ADDENDUM NO. 3
05/06/2024

PROJECT: CITY OF IDALOU
WATER TREATMENT IMPROVEMENTS

CITY OF IDALOU
WATER SYSTEM IMPROVEMENTS – CONTRACT 1 – WATER TREATMENT IMPROVEMENTS
BASE BID - ADDENDUM #3

IDALOU, TEXAS
WATER TREATMENT IMPROVEMENTS
RAW WATER TANK DETAILS

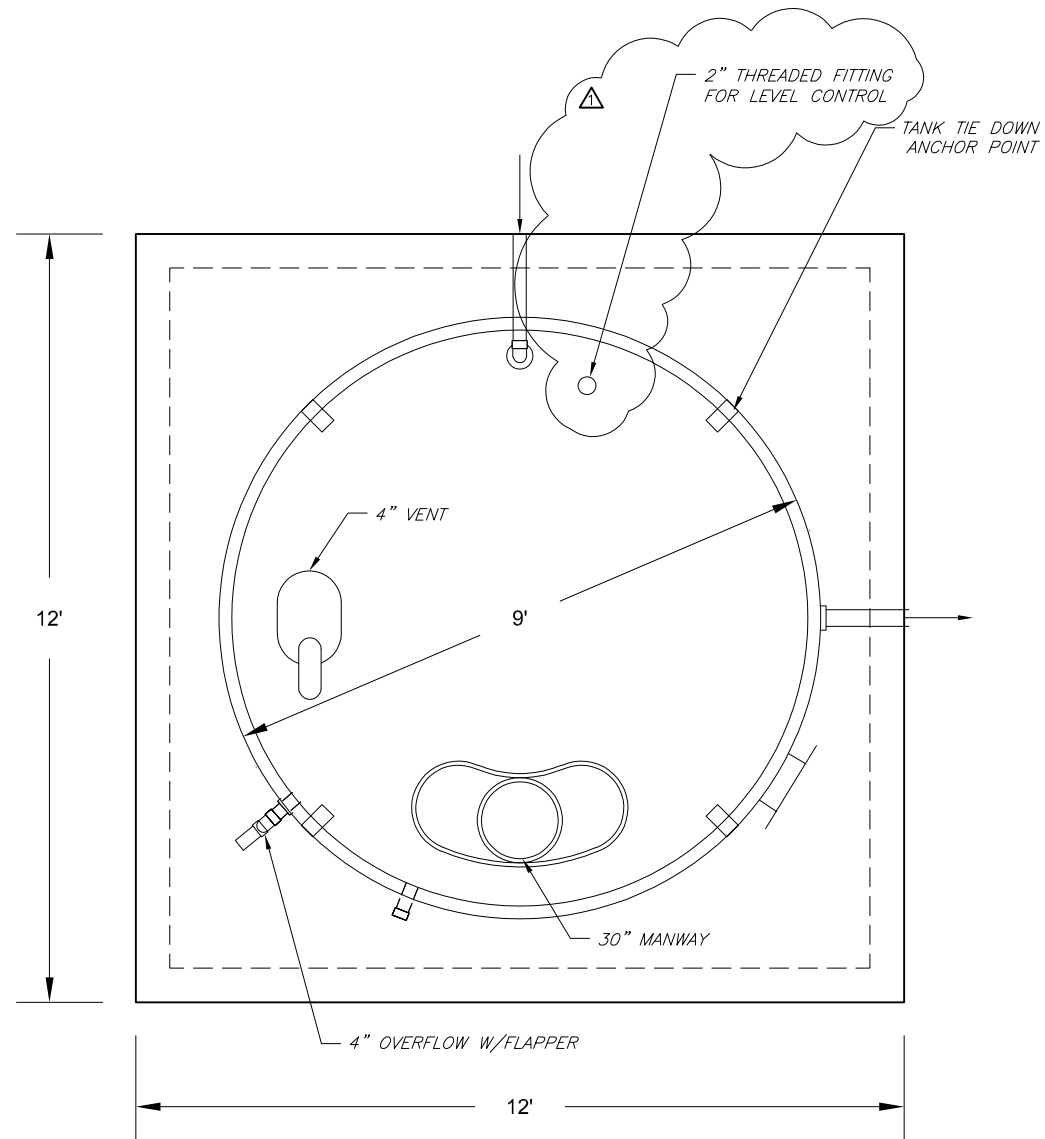
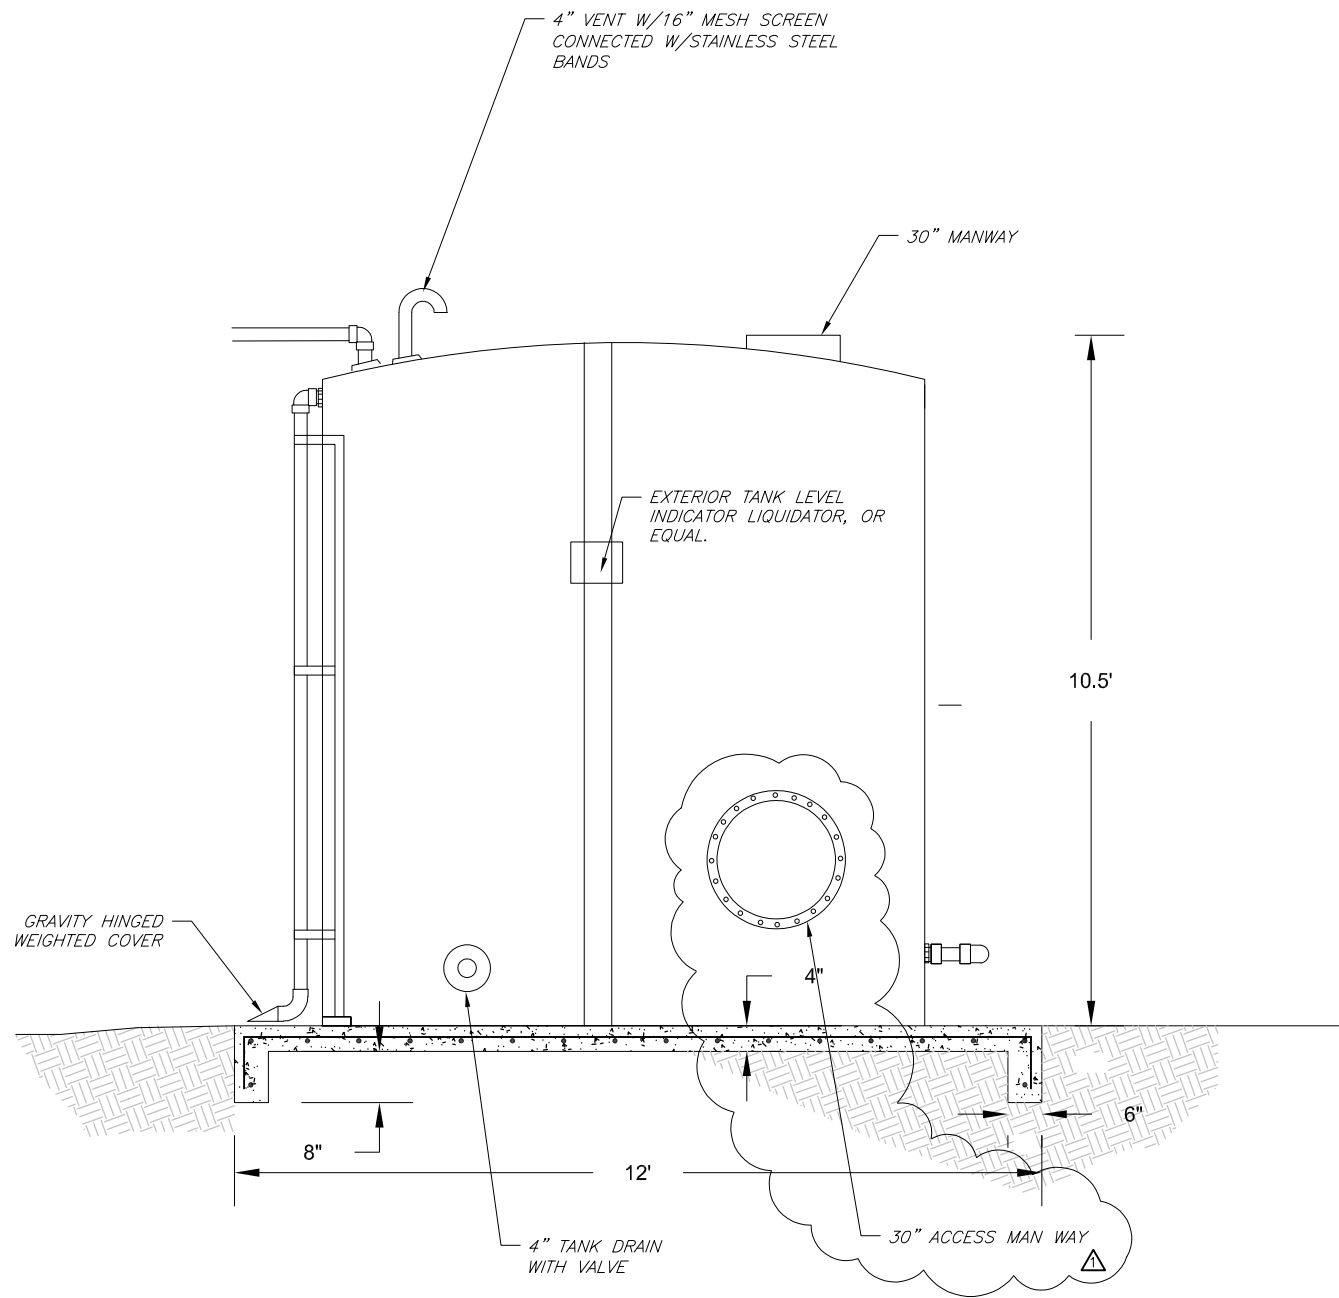
- a) Sheet C-14 – This sheet has been revised to add a side access manway per TCEQ requirements and a 2” threaded fitting.
- b) Sheet C-15 – This sheet has been revised to show a double barrier boom gate instead of the single boom configuration.
- c) Sheet D-2 – This sheet has been revised to clarify verbiage related to the feed pump.
- d) Sheet D-3 – This sheet has been revised to provide additional details on the feed and booster pumps.
- e) Sheet D-7 – This sheet has been revised to add a butterfly valve after the feed pump and details on possible deductive alternate.
- f) Sheet D-11 – This sheet has been revised to clarify the water treatment system controls.

WTP BUILDING SECTION 4

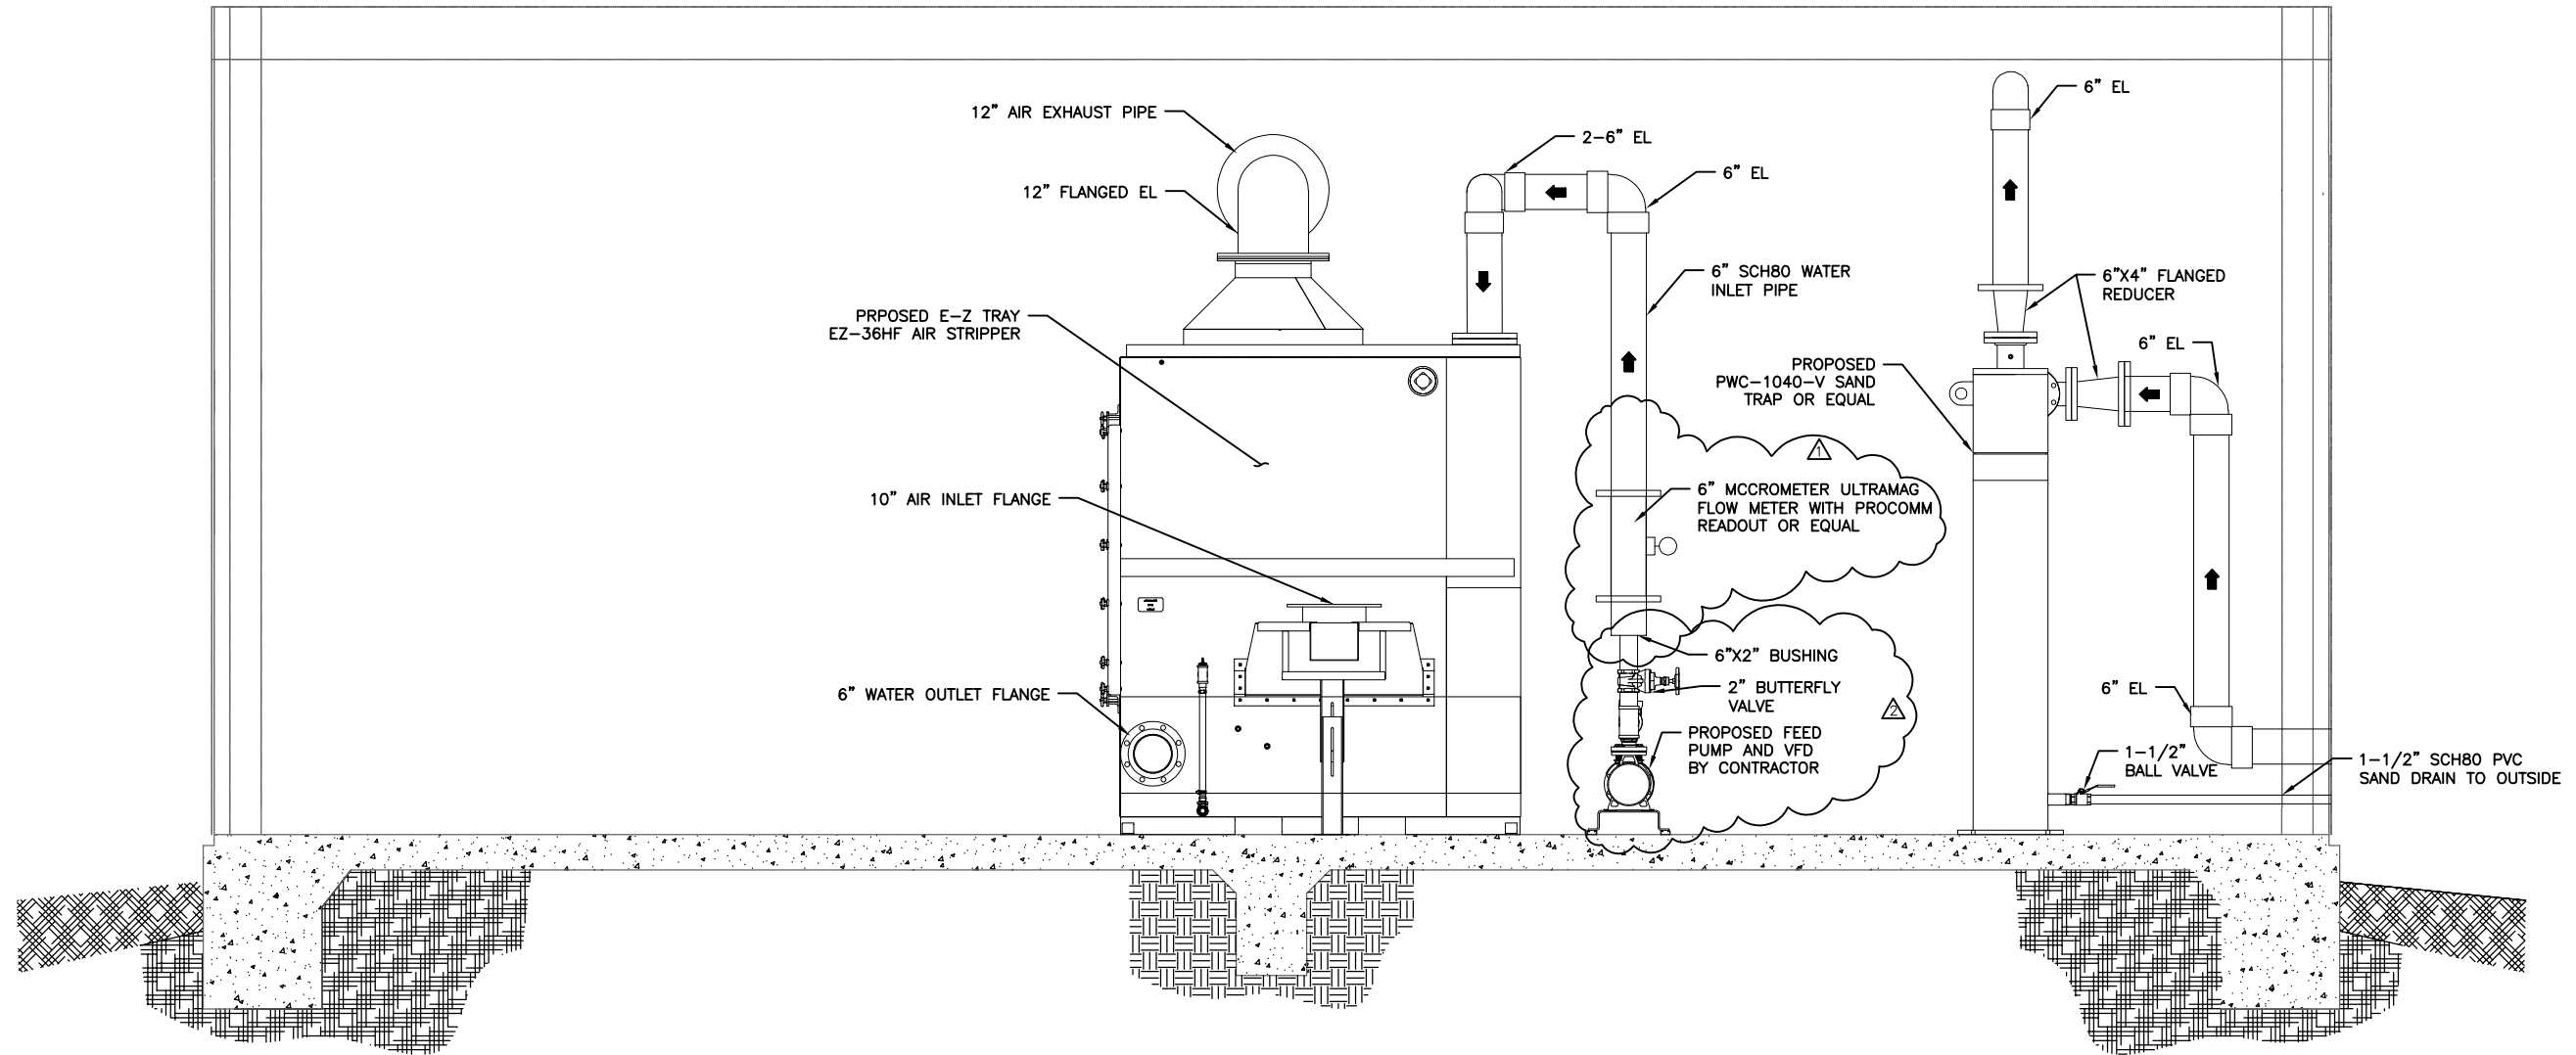
NOTE:
 1) SAND TRAP IS DEDUCTIVE LINE ITEM D4. IF
 DEDUCTIVE ITEM D4 IS SELECTED, CONTRACTOR TO
 INSTALL FLANGED SPOOLS SO THAT SAND TRAP
 MAY BE INSTALLED AT A LATER TIME IF NEEDED.
